Liverpool City Council

Liverpool Civic Place Stage B
& C

**Access Review –
Final**

10th December 2020

DA-AR-2005

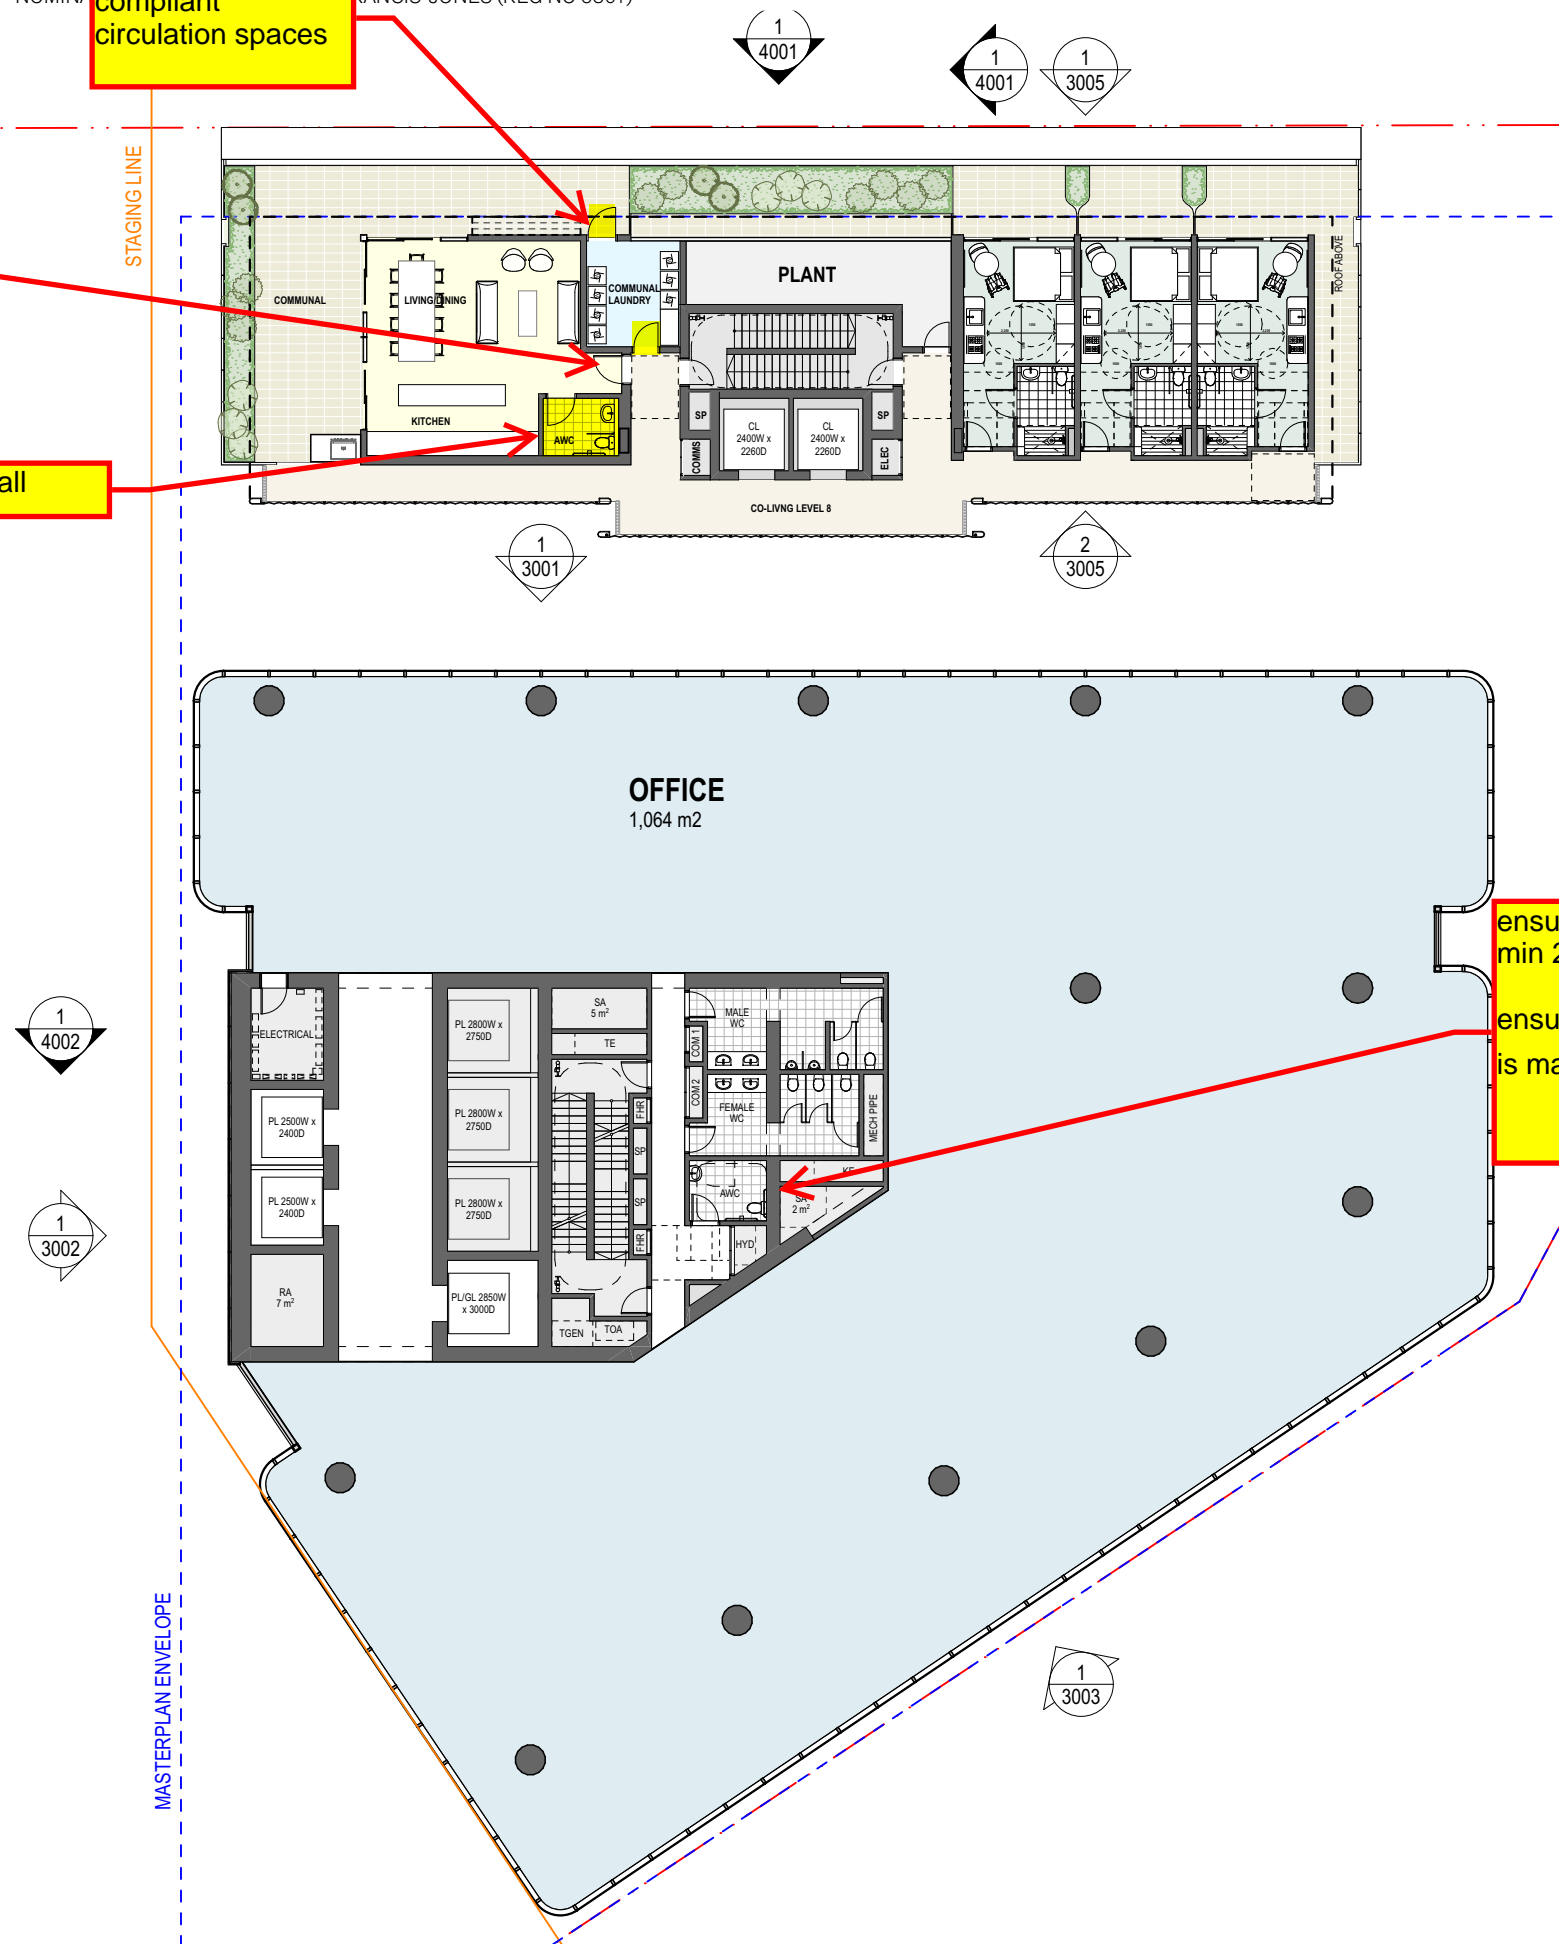
ensure compliant
door latch side
clearance

ensure door have
compliant
circulation spaces

room to small

ensure room length of min 2630mm

ensure 1m wide corridor
is maintained

MGAC Comments for accessible boarding rooms

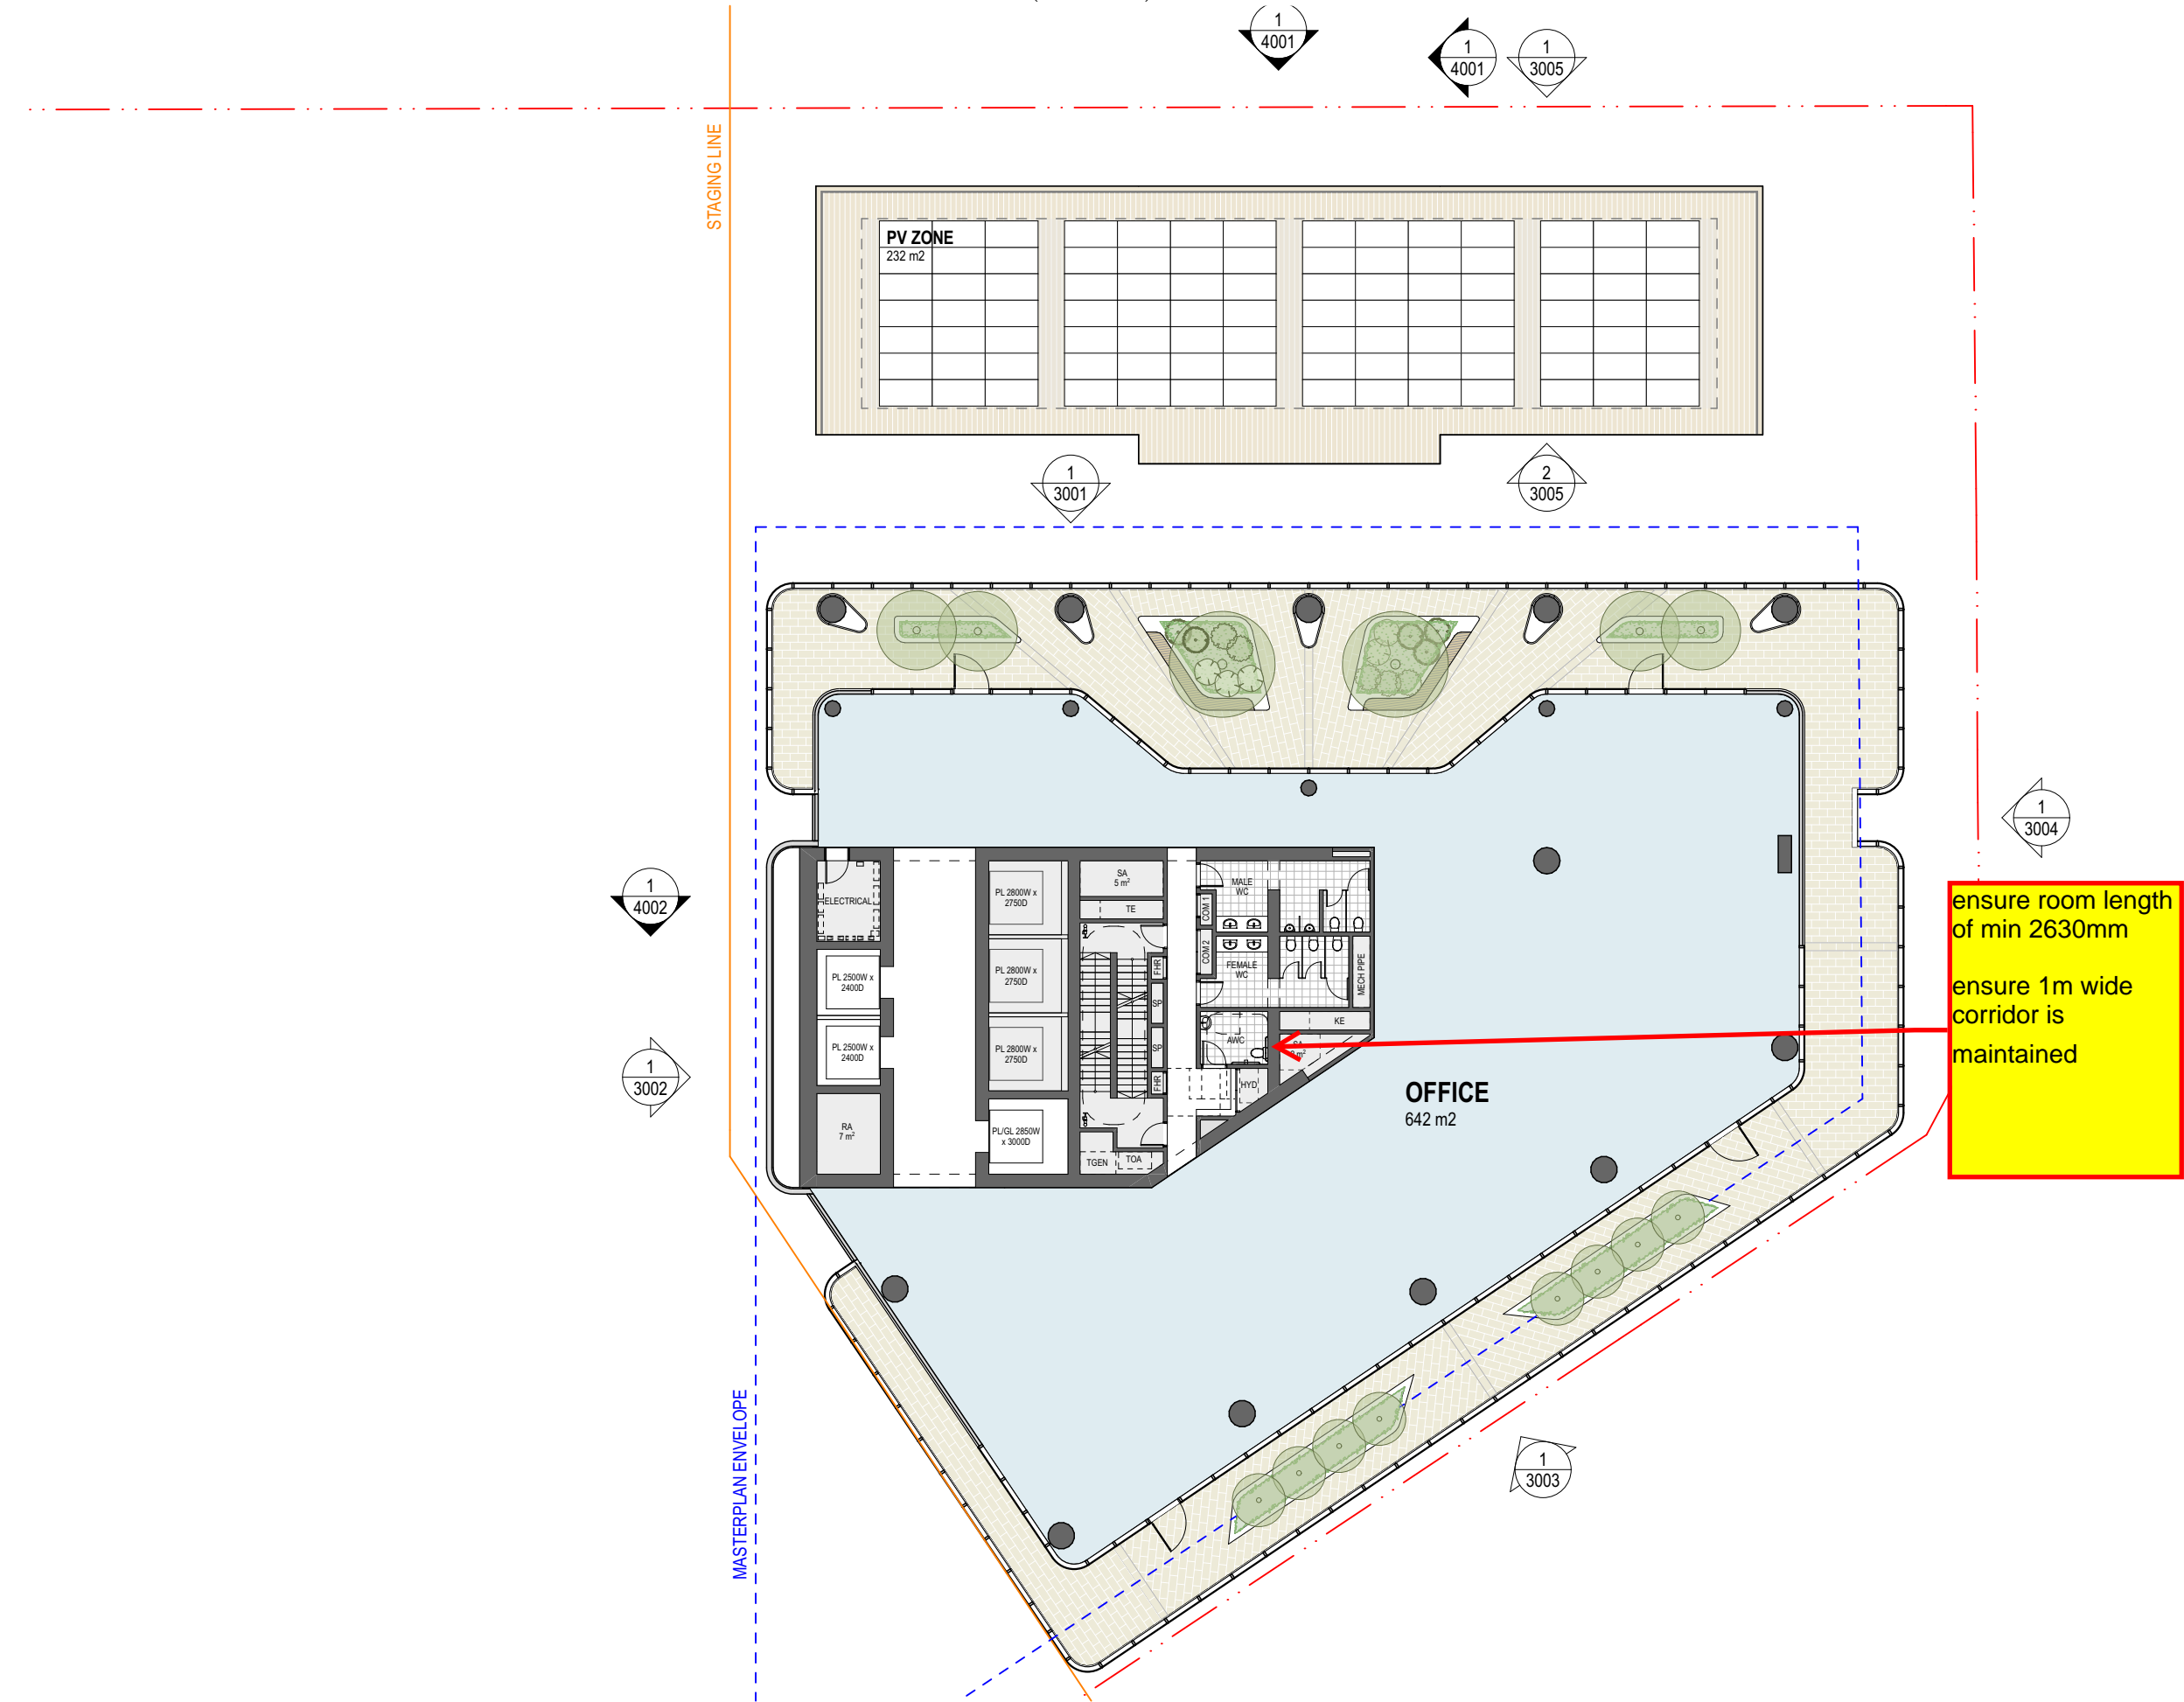
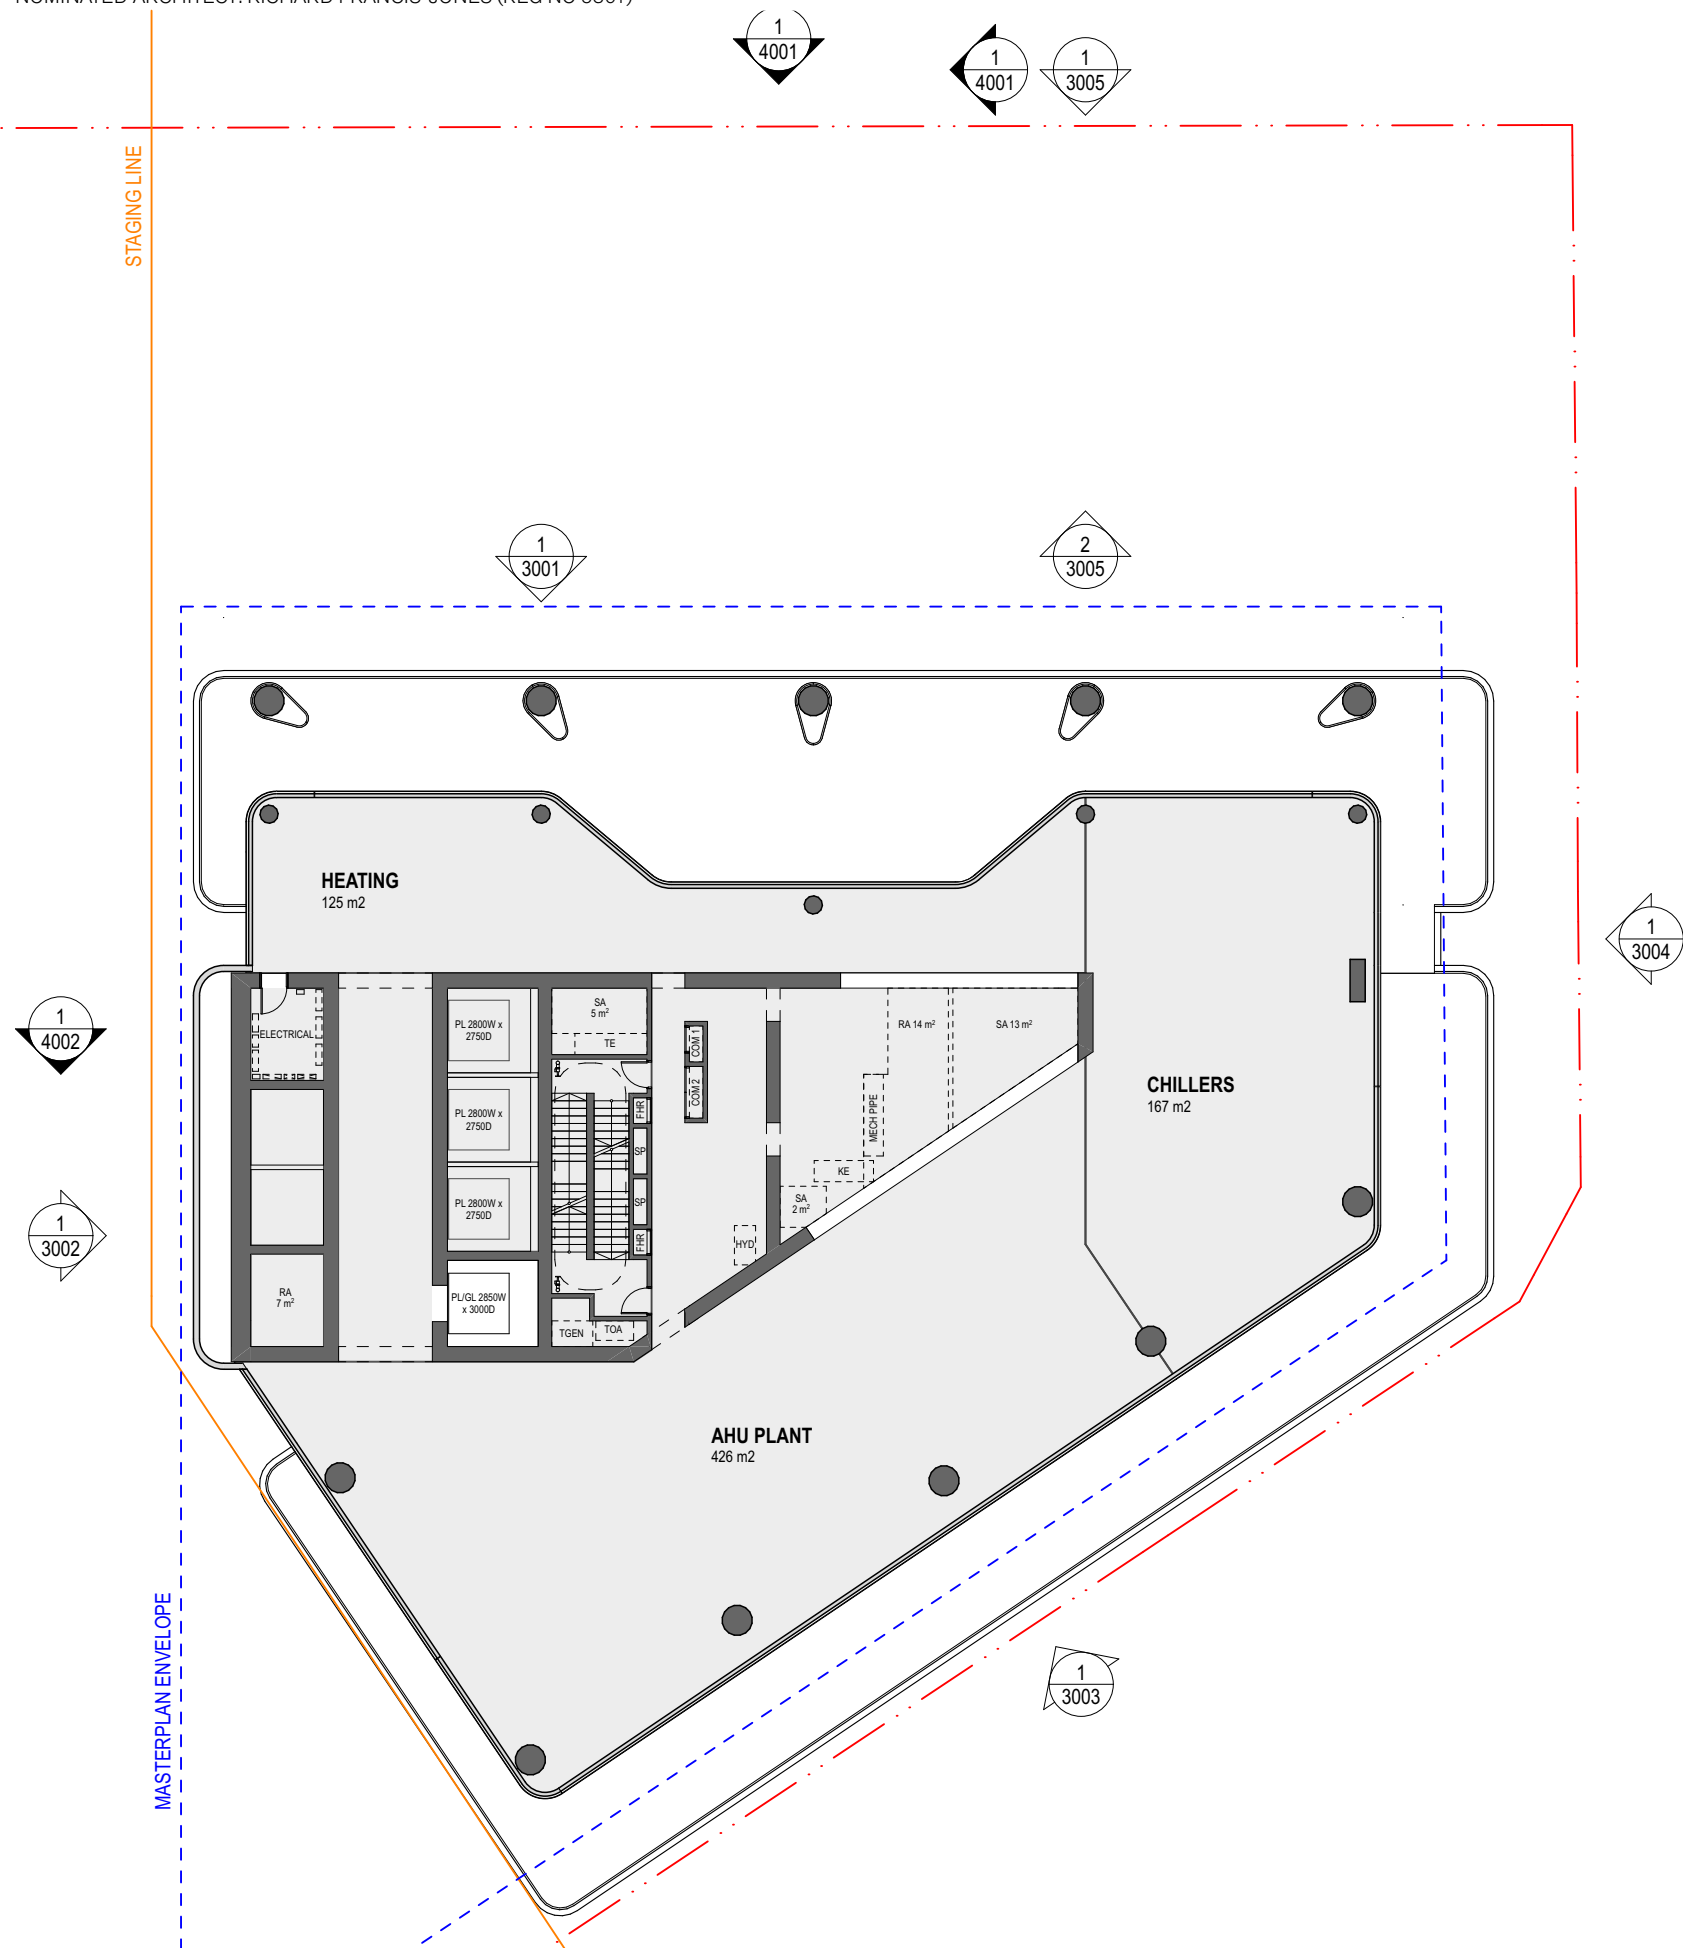
1. 1m clear width required either side of the bed
2. width of AWC to be 2350mm - currently measures 2300mm.
3. AWC to be reviewed - ensure min 2630mm x 2350mm internal demesion.
4. Ensure level access required onto balcony.
